Re: 291 Homer Street, Site No.: C905042
Olean, Cattaraugus County
SSDS Decommissioning Plan Response

Re: 291 Homer Street, Site No.: C905042
Olean, Cattaraugus County
SSDS Decommissioning Plan

TITLE: NEW PAINT SHOP SSDS DECOMMISSION PLAN

DRAWING NO. 1

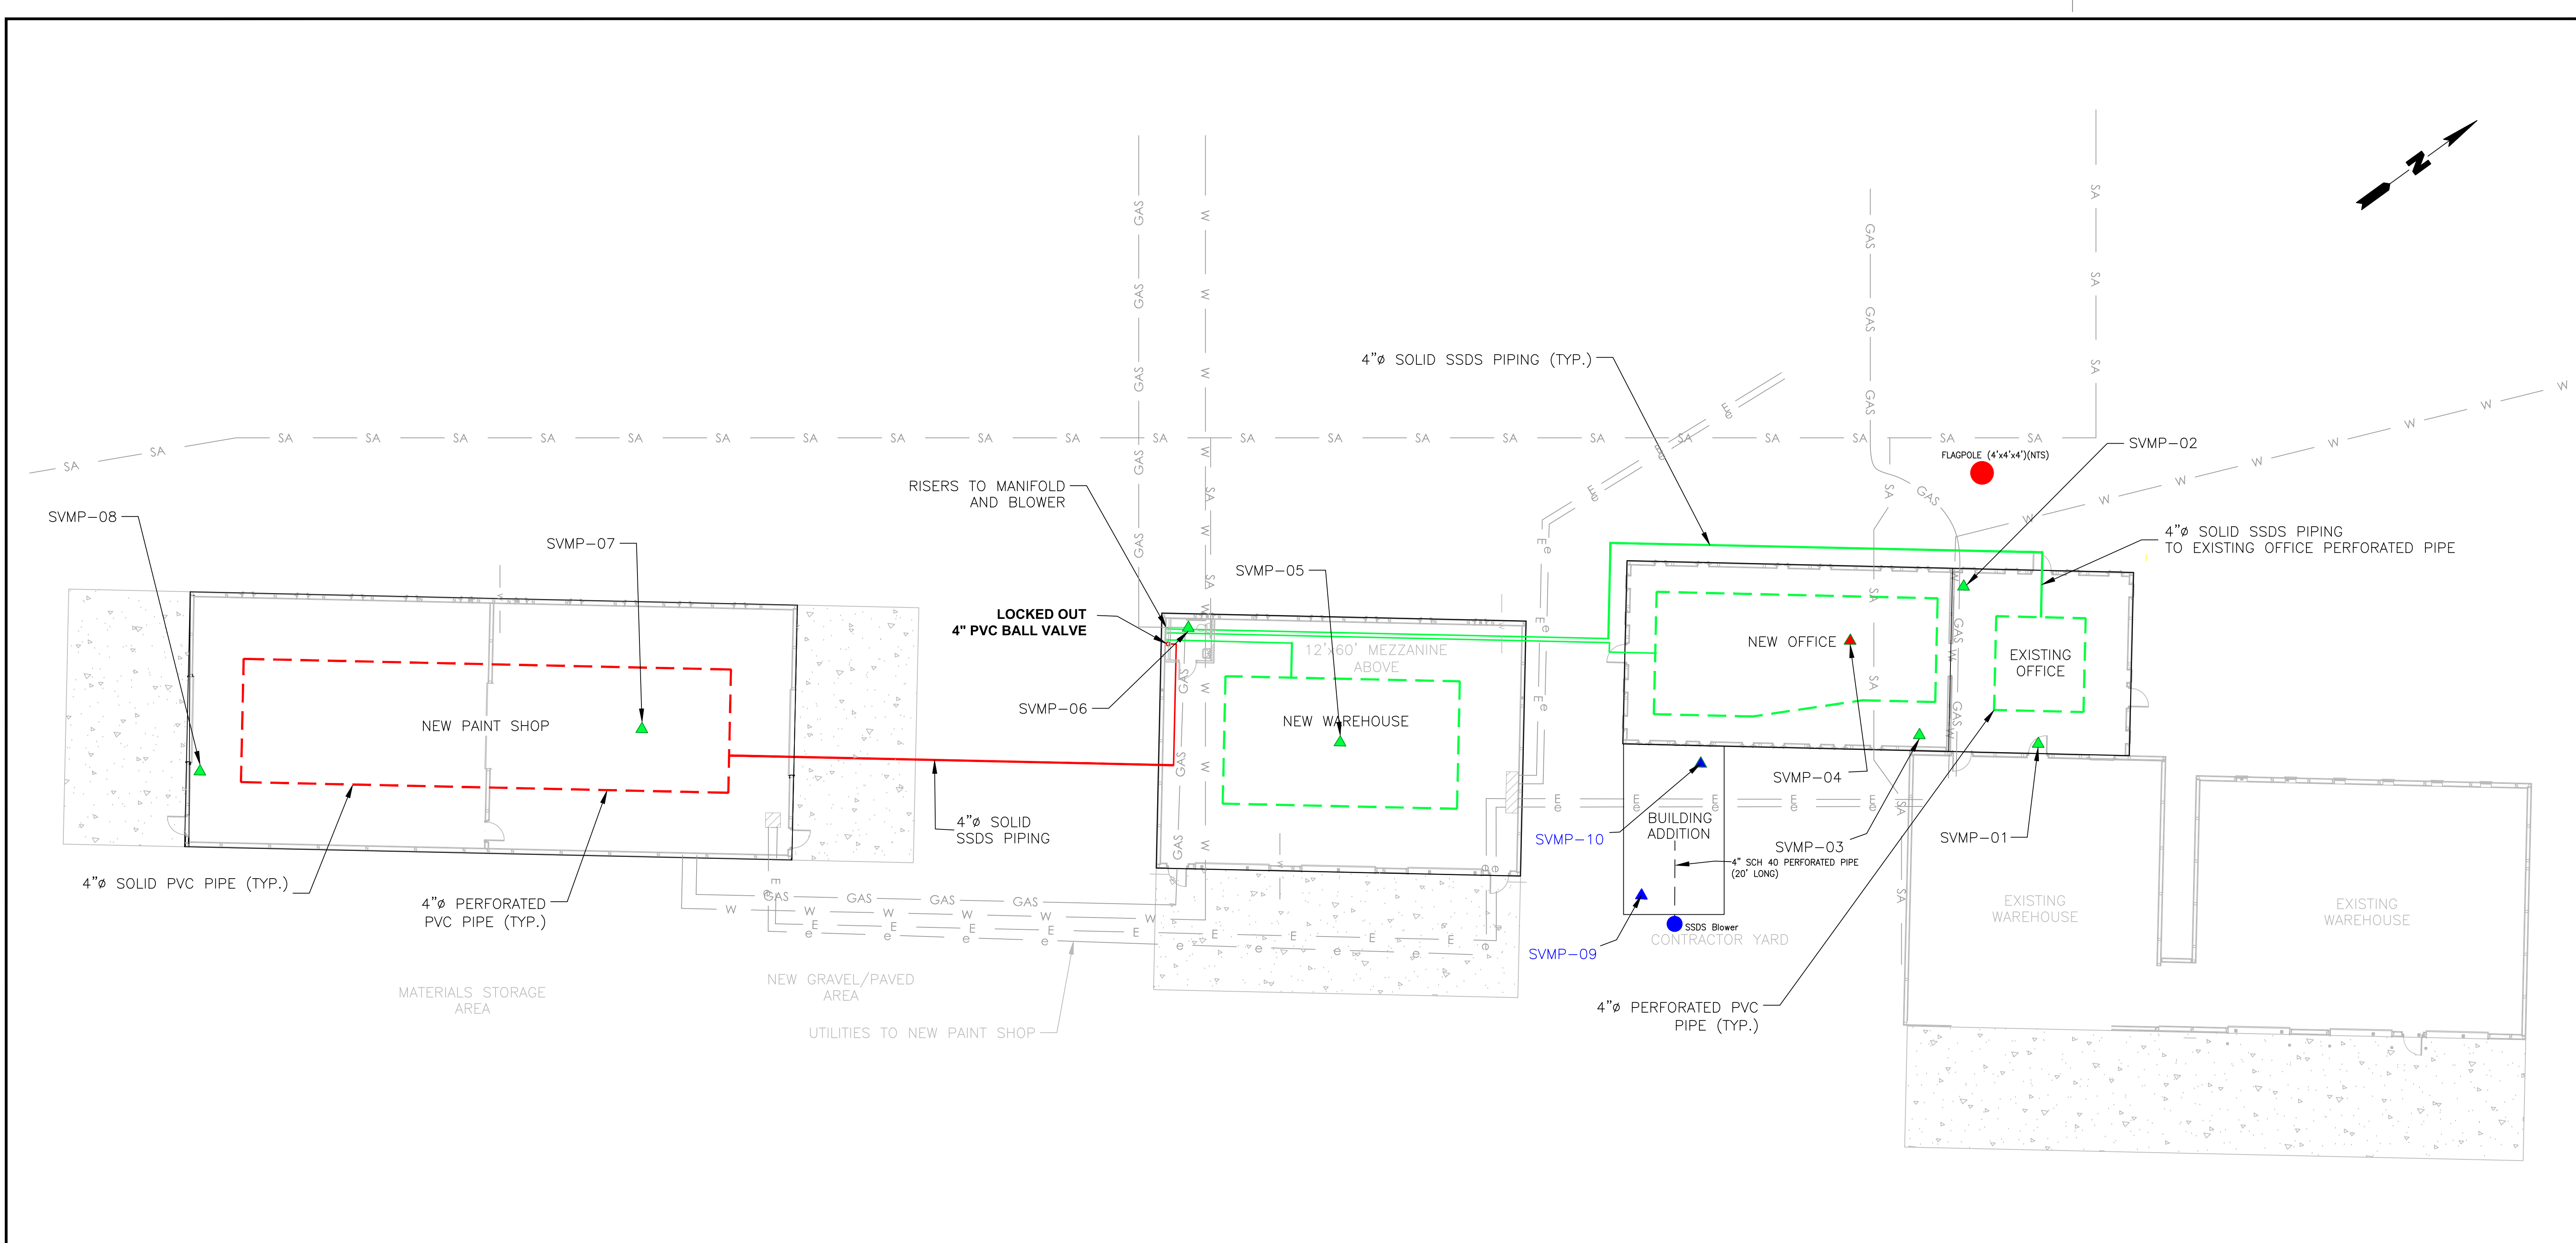
- 2) Confirmation Sampling: while NYSDEC acknowledges the results from the previous sampling events, it was stated in the 2025 *Performance Monitoring Report* that "it is Roux's recommendation that operation of the New Paint Shop portion of the SSDS remain discontinued and the SMP be amended to reflect this change upon receipt of confirmatory analytical data during the 2026-2026 heating season SVI". It is not clear what has changed since that report was submitted to no longer include confirmatory sampling. Given the timing of the work plan submittal and our review time, such confirmatory sampling should be completed during the 2026-2027 heating season. The New Paint Shop SSDS may remain off during this time; and

Revised to include confirmatory sampling completed consistent with the previous Work Plan during the 2026-2027 heating season.

Upon receipt of NYSDEC approval (and pending confirmation via the proposed 2026-2027 heating season SVI analytical results) Roux plans to decommission the NPS SSDS by locking out the 4-inch PVC valve (Figure 1). The proposed method of decommissioning does not include cutting, capping, or grouting of the NPS SSDS piping.

Title:			
Engineering Controls			
291 and 299 Homer Street, Olean, New York			
Prepared For: MJ Painting Contractor Corp.			
REMEDIAL ENGINEERING, P.C.	Compiled By: DC	Date: 9/27/2016	FIGURE 2
	Prepared By: AH	Scale: AS SHOWN	
	Project Mgr.: DC	Office: MA	
	File No.: 09.006	Project: 2137.0001M006

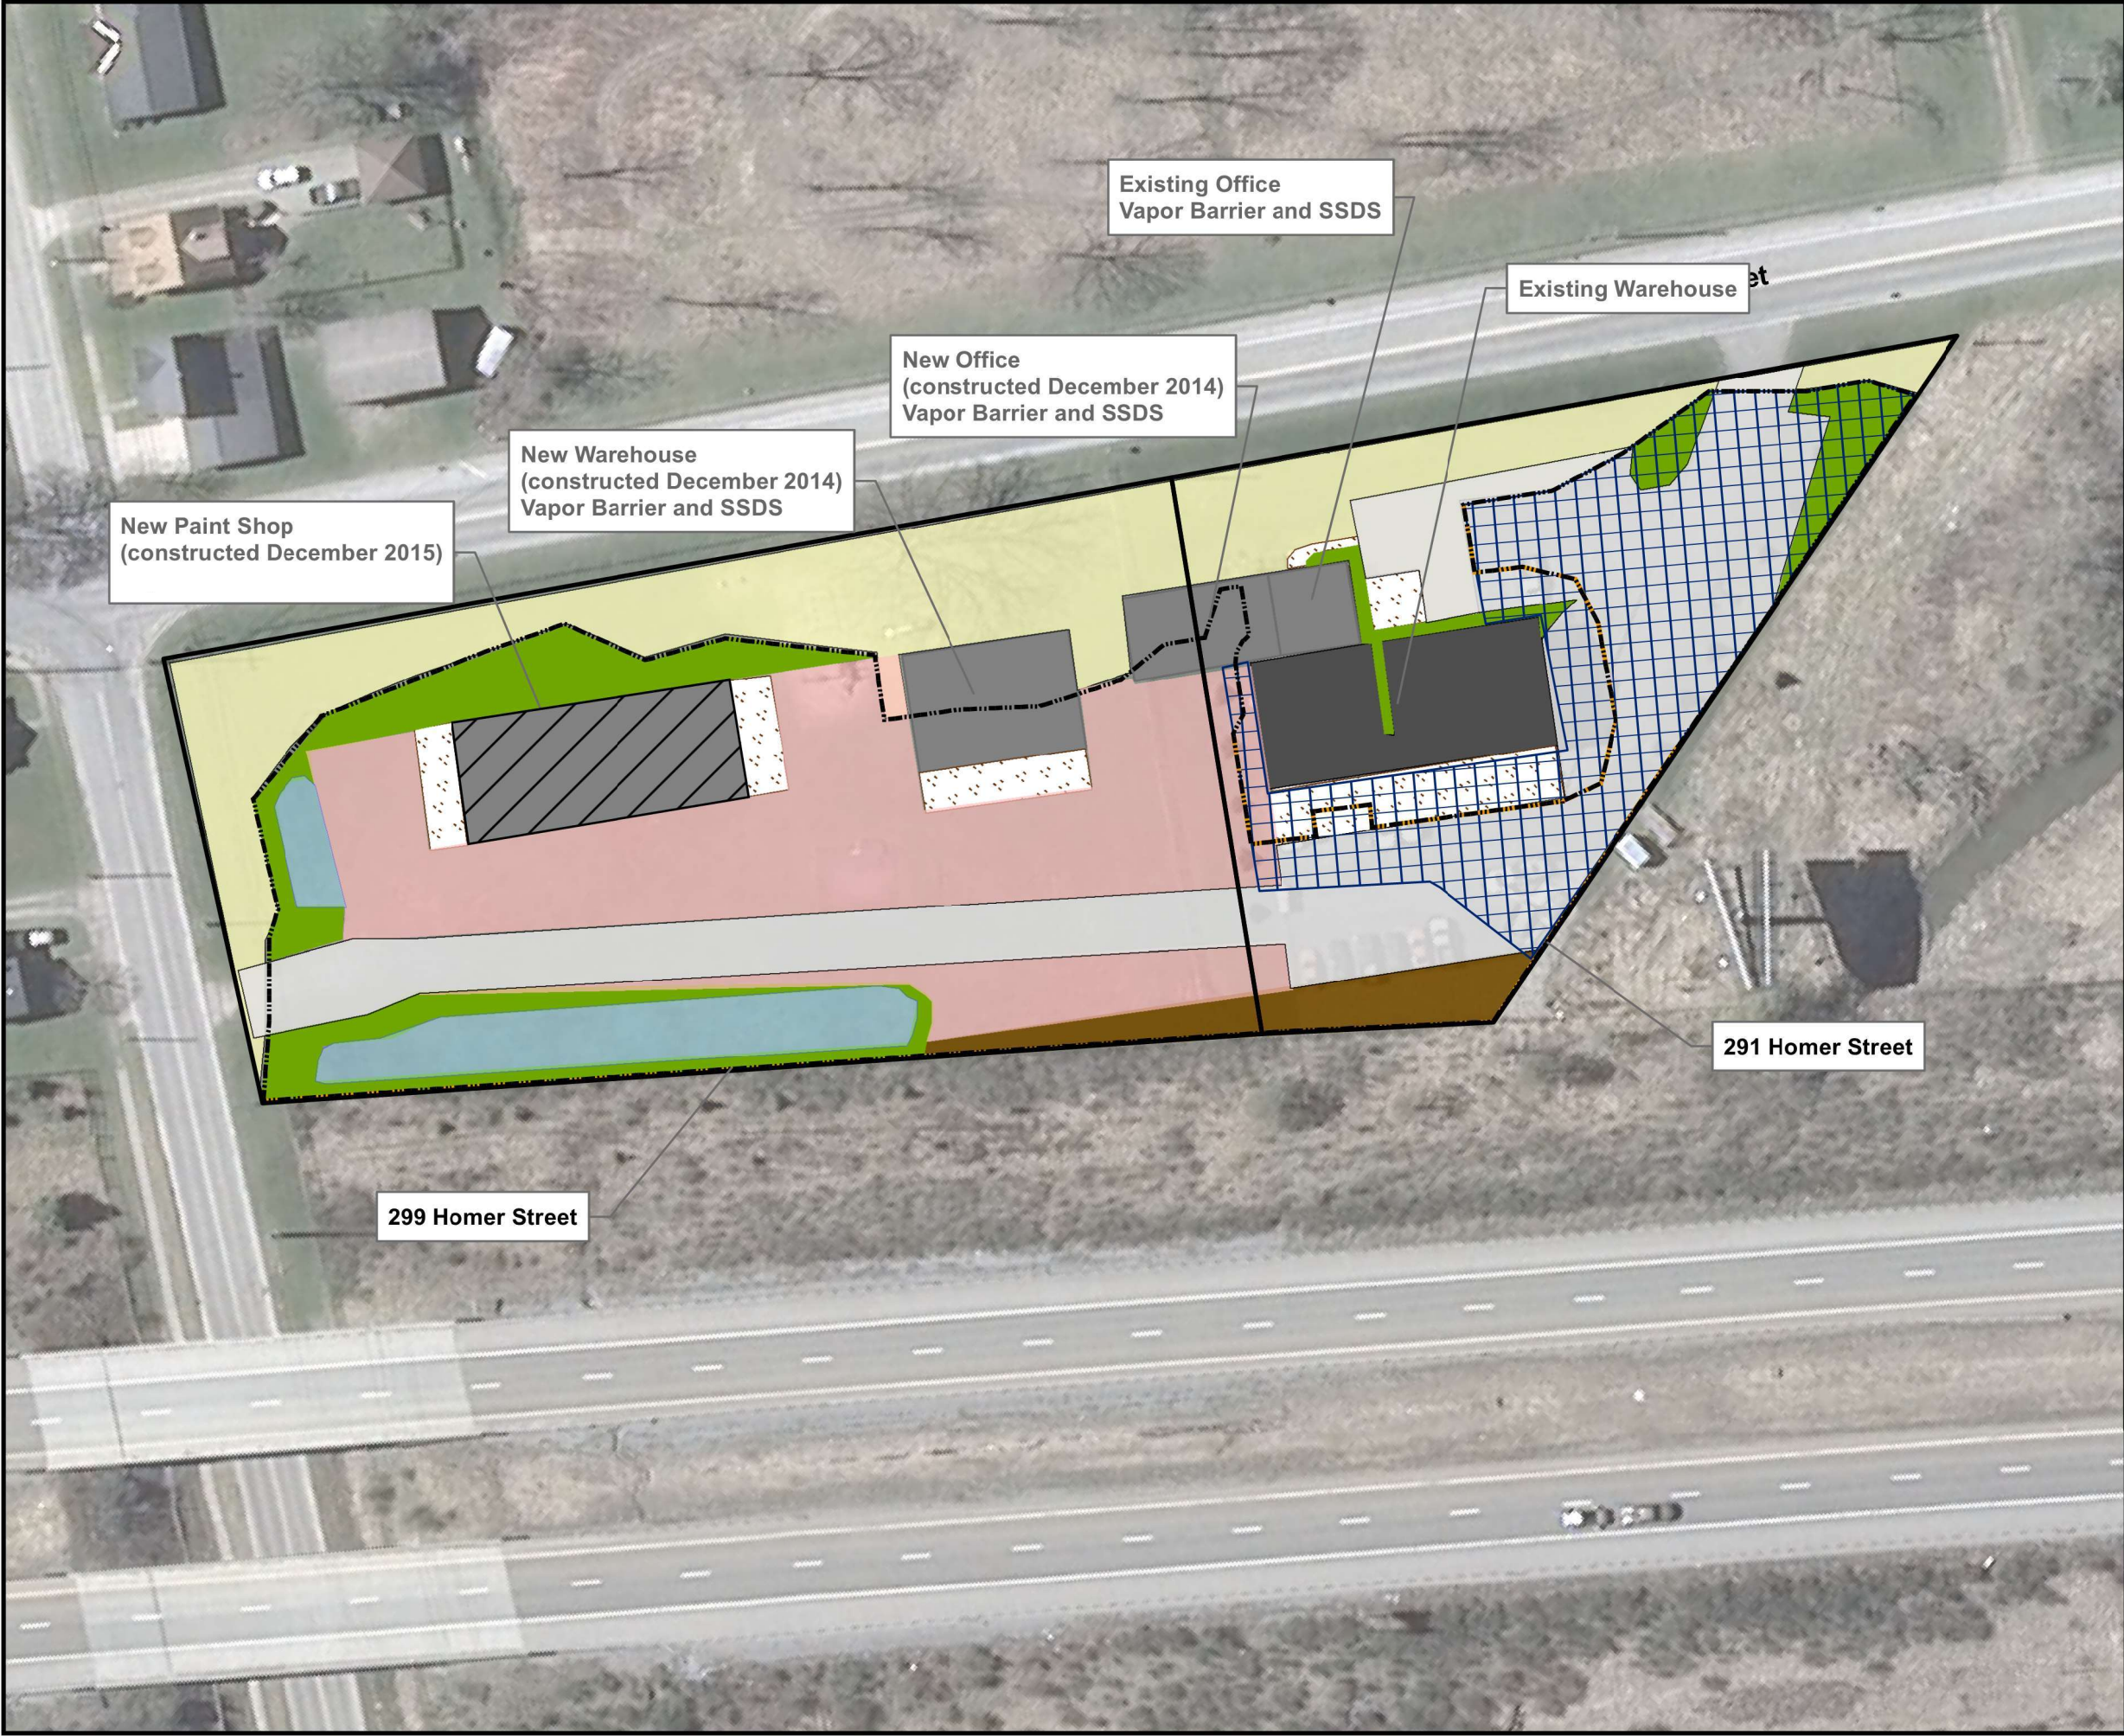
- 3) Figure 2: it is not clear what is meant by the "Areas to be excluded from the IC boundaries" feature shown on this figure. The outline of the feature appears to correspond to the New Paint Shop, but the shutdown of the SSDS in that building does not remove the institutional control (IC) from that area. The environmental easement will still be in effect for the whole site. Clarification of this is needed.

Noted, the IC Figure 2 has been removed from the revised current submission.
